UNITED STATES PATENT AND TRADEMARK OFFICE

APPLICATION NO.	FILING DATE	FIRST NAMED INVENTOR	ATTORNEY DOCKET NO.	CONFIRMATION NO.
10/659,384	09/11/2003	Geum-Jong Bae	239/169 DIV	3795
7590	12/08/2005		EXAMINER PHAM, HOAI V	
LEE & STERBA, P.C. SUITE 2000 1101 WILSON BOULEVARD ARLINGTON, VA 22209			ART UNIT 2814	PAPER NUMBER

Office Action Summary

DETAILED ACTION

FIG. 3e

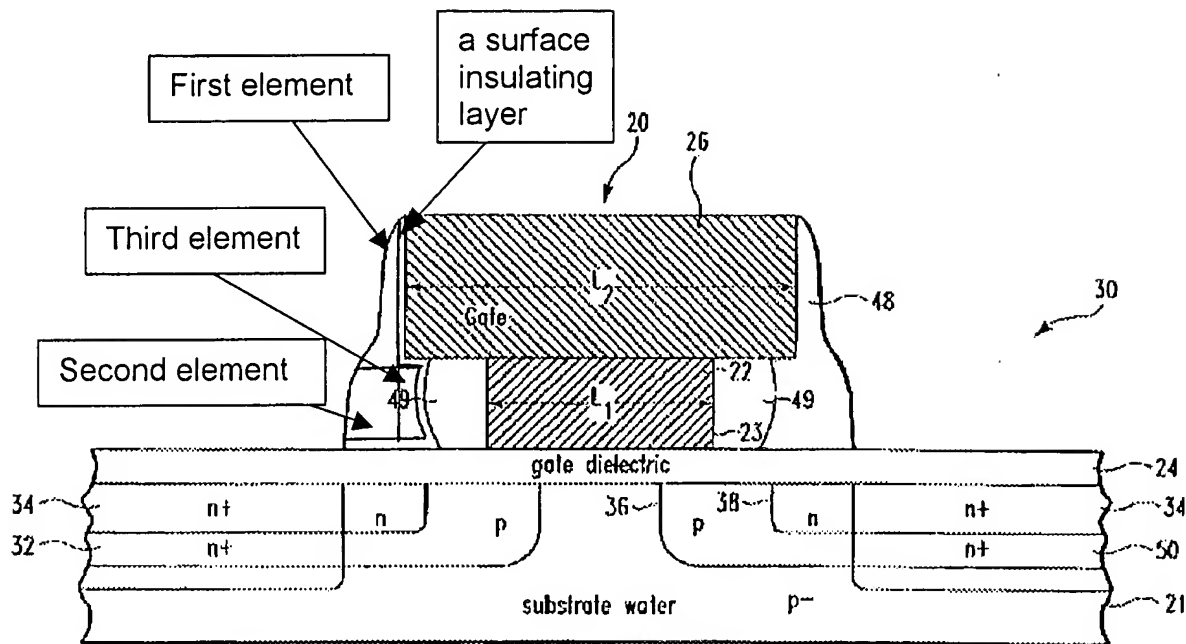
With respect to claims 20, Furukawa et al. discloses (fig. 3e, cols. 4-5) a semiconductor device comprising:

a T-shaped gate electrode (20) disposed on a semiconductor substrate (21), the T-shaped gate electrode (20) having a wide portion (26) and a narrow portion (22), the narrow portion disposed between the wide portion and the semiconductor substrate (21), so as to have an undercut region adjacent to the narrow portion;

an L-shaped lower spacer (48) covering a top surface of the semiconductor substrate at both sides of the T-shaped gate electrode (20) and covering sides of the wide portion of the T-shaped gate electrode (20), the L-shaped lower spacer (48) having a first element disposed substantially perpendicular to the semiconductor substrate (21), and having a second element disposed substantially parallel to the semiconductor substrate, the second element extending from the first element laterally away from the T-shaped gate electrode (20);

a low-concentration impurity region (34) formed in the semiconductor substrate at both sides of T-shaped gate electrode (20); and

a high-concentration impurity region (50) formed in the semiconductor substrate next to the L-shaped lower spacer (48).

Furukawa et al. fails to disclose a mid-concentration impurity region disposed between the high-and low-concentration impurity regions (50 and 34). However, Matsuda discloses that a mid-concentration impurity region (28) is disposed between the low-concentration impurity region (26) and high-concentration impurity region (34) (see fig. 3 and col. 9, lines 39-41). Therefore, it would have been obvious to one having ordinary skill in the art to modify the device of Furukawa et al. by having a mid-concentration impurity region disposed between the high- and low-concentration impurity regions as taught by Matsuda in order to provide the known purpose of lower electrical field thereby improving hot carrier performance.

With respect to claim 21, Furukawa et al. discloses that lower and upper conductive layer patterns (22 and 26) are sequentially stacked, wherein the upper conductive layer pattern (26) is wider than the lower conductive layer pattern (22) (see fig. 3e).

With respect to claim 22, Furukawa et al. discloses that the L-shaped lower spacer (48) further comprises a third element extending into the undercut region, the third element disposed substantially parallel to the semiconductor substrate and extending from the first element laterally towards the T-shaped gate electrode (fig. 3e).

With respect to claim 26, Furukawa et al. discloses that a surface insulating layer (48) intervened between the gate electrode (20) and the lower spacer (48) (see fig. 3e).
****Notice:** as interpreting the claim in a broad scope, a surface insulating layer can also be the same as the lower spacer because the claims do not distinct the material of the lower spacer and the surface insulating layer. Therefore, the lower spacer and the surface insulating layer are considered as one layer.

With respect to claim 27, Furukawa et al. discloses that the first element of the L-shaped lower spacer (48) completely covers sides of the wide portion (26) of the T-shaped gate electrode (20) (see fig. 3e).

With respect to claim 28, Furukawa et al. discloses that the second element of the L-shaped lower spacer (48) partially covers the narrow portion (22) of the T-shaped gate electrode (20) (see fig. 3e).
